# Access Compliance Report

## Public Rights-of-Way

### (Curb Ramps)

Intersection ID: 11231	Main Street: W_4TH_ST_EXT	Cross Street: WALNUT_AV	Location: S
ADA ID: F90892F7B3D7	Ramp Type: Directional1	Initial Pass/Fail: Pass	Overall Compliance: No
Severity Score: 0.25			
Codes/Mitigation Info/Possible Solution		Field Measurements/Component Compliance

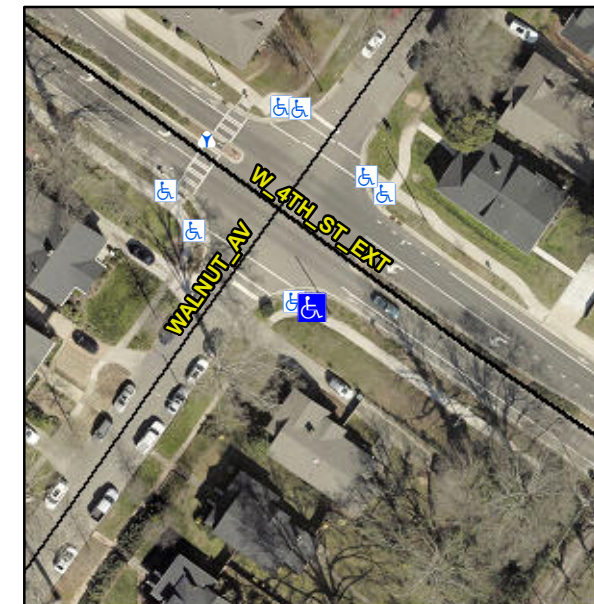
**Remove & Replace Gutter.**

**R304.5.3**
